MAINE YANKEE ATOMIC POWER COMPANY •

Proposed Change No. 83
Supplement No. 1
2.C.2.1

Subject: Modifications and Additions to Maine Yankee Technical Specifications
Concerning Administration.

MAINE YANKEE ATOMIC POWER COMPANY
OFFSITE ORGANIZATION
FIGURE 5.2-1

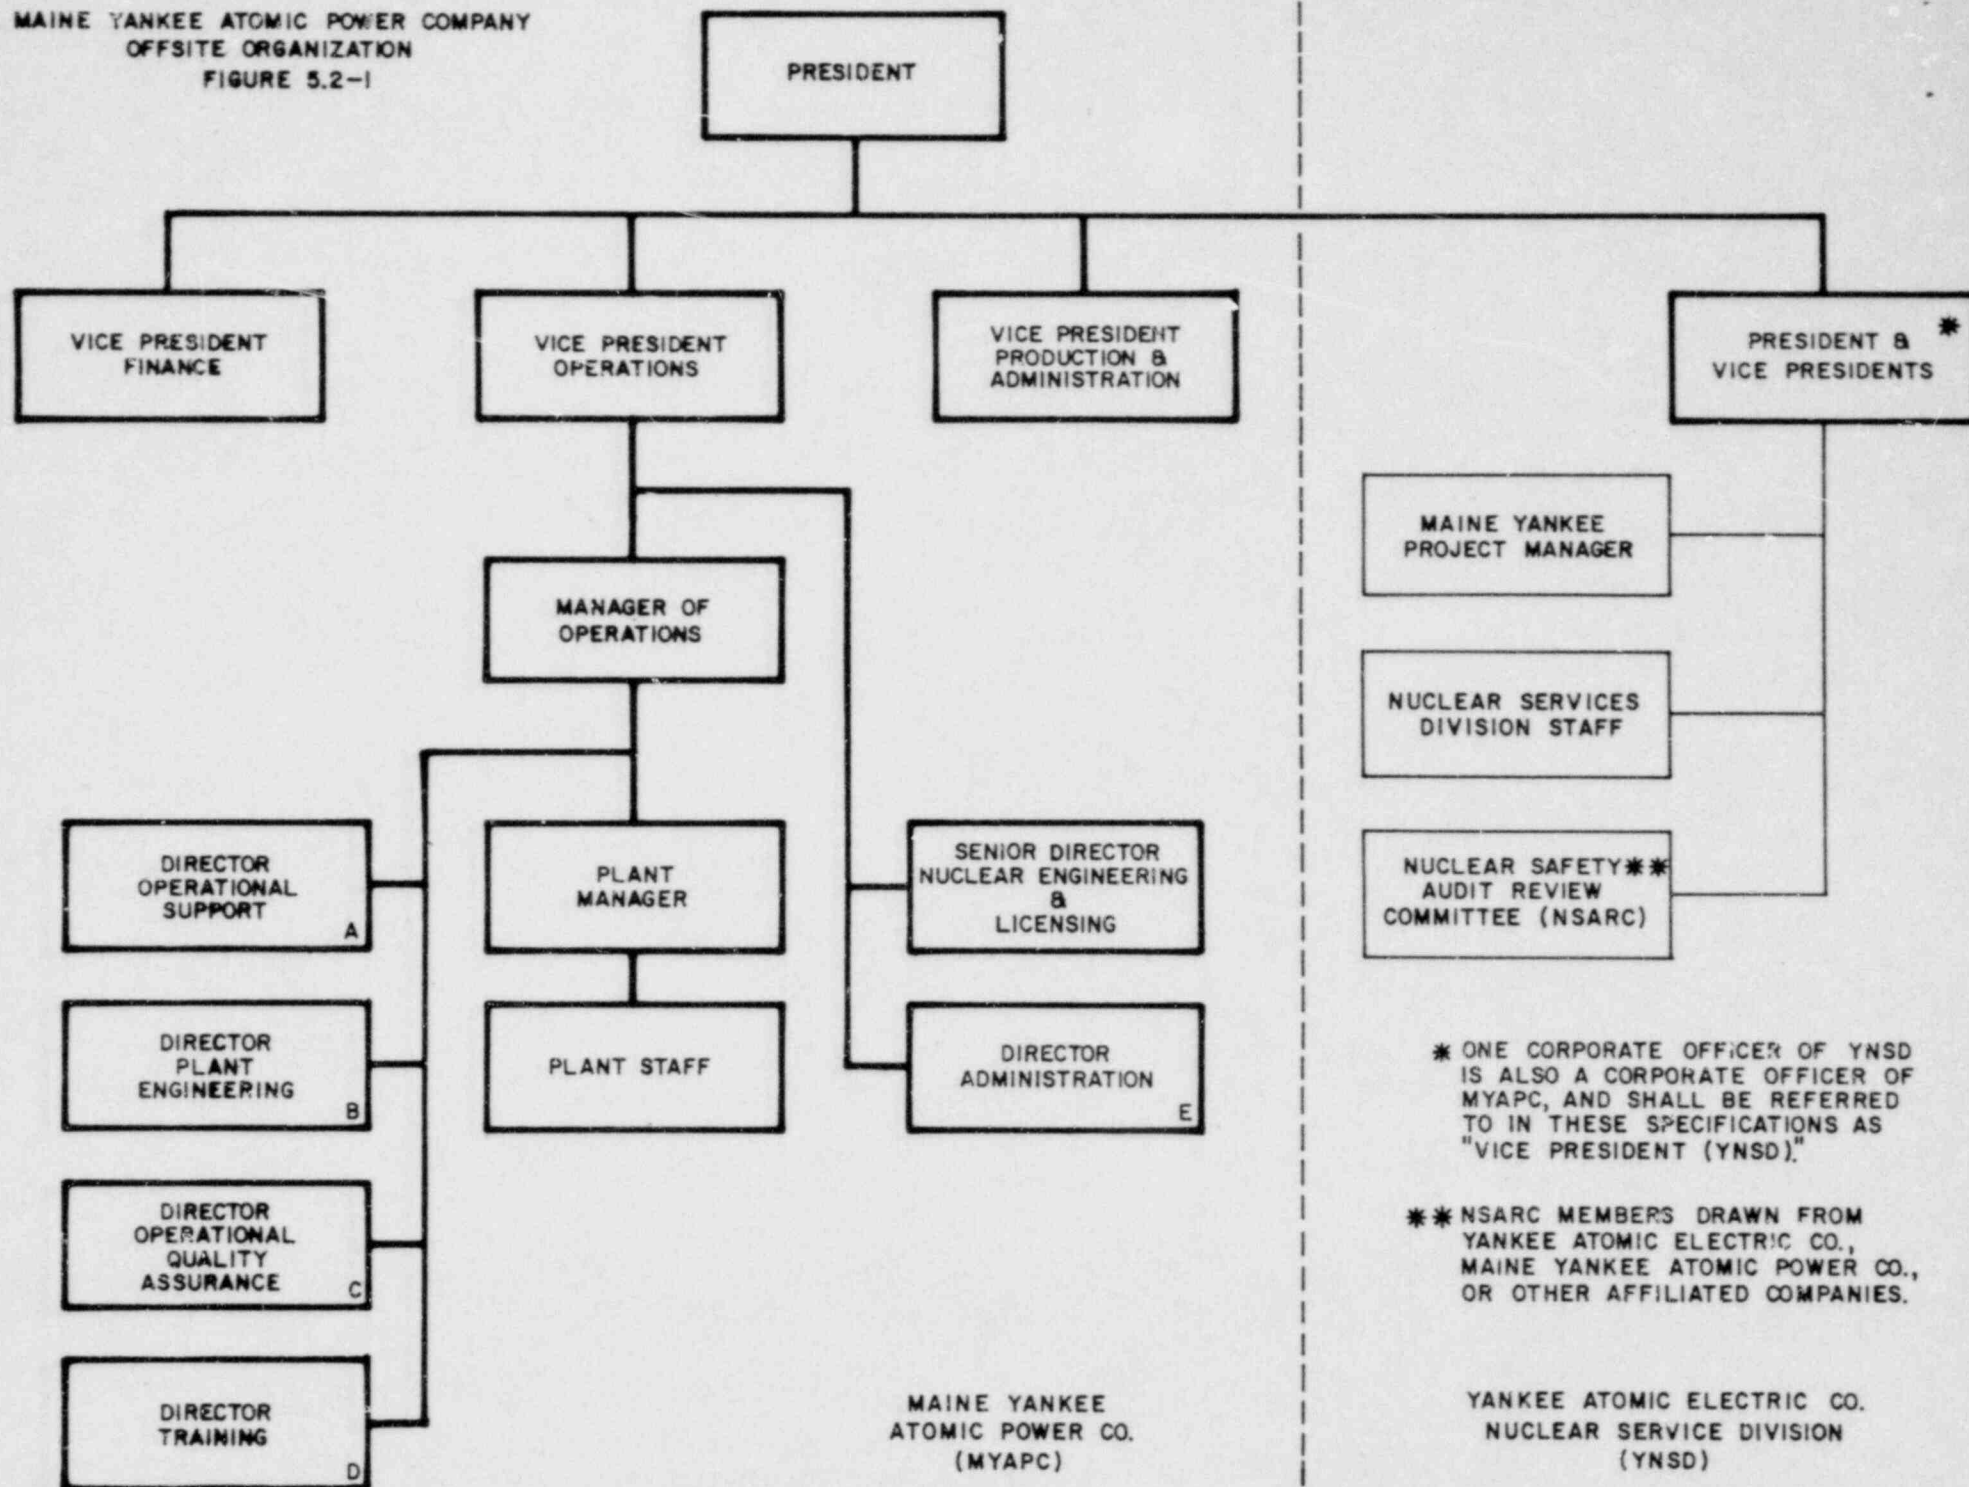
Replace pages 5.2-2 (Fig. 5.2-1) and 5.2-3 (Fig. 5.2-2) of Specification 5.2 with the attached revised pages 5.2-2 and 5.2-3.

- 0 The Nuclear Engineering and Licensing department will report directly to a corporate officer. This department shall function as the focal point for Maine Yankee's interface with the Nuclear Regulatory Commission.
- 0 The Manager of Operations will now be a separate position reporting directly to a corporate officer. This position shall be responsible for operational management of the plant and corporate support staff, and for coordination of these activities with other corporate entities.
- 0 The organizational relationships of certain specific plant functions (Fire Protection and Security) have been revised to provide a more efficient management structure.
- 0 Administrative functions will be coordinated through a corporate level office.
- 0 Other changes reflect title changes.
